Product Change Notification

1. ECN #: 293386

- CAT-HT - Application Tooling

CAT-HT-XXX-XXXX-11 (OLD)

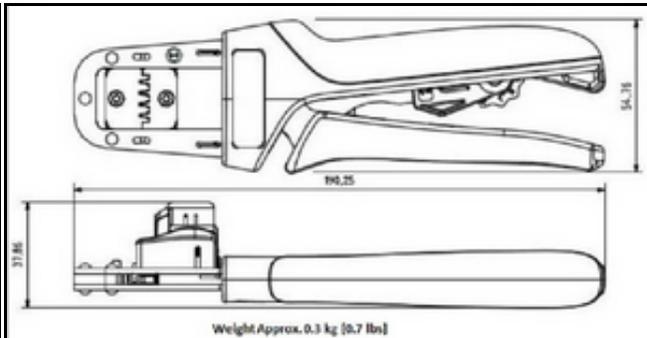
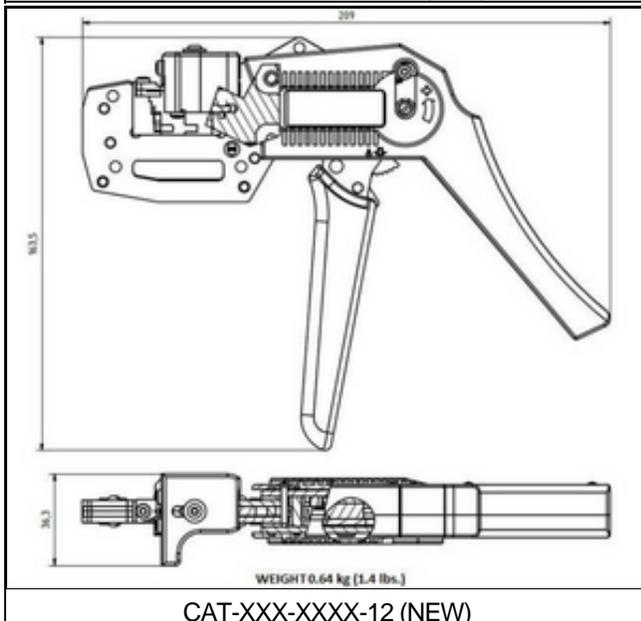
CAT-HT-383-2426-13 is replacing CAT-HT-383-2426-11. CAT-HT-144-2830-12 & CAT-HT-203-2830-12 are replacing CAT-HT-203-2832-11.

- Function - CAT-HT-XXX-XXXX-12 does not accept loose piece. They do not have an insulation adjustment.
- Form - CAT-HT-XXX-XXXX-12 has a pistol-like shape, where the -11 has a plier-like shape.
- Function - CAT-HT-XXX-XXXX-13 has a built-in locator to aid in placing the contact prior to crimping. They do not have an insulation adjustment.
- Form - CAT-HT-XXX-XXXX-13 is slightly smaller and lighter.
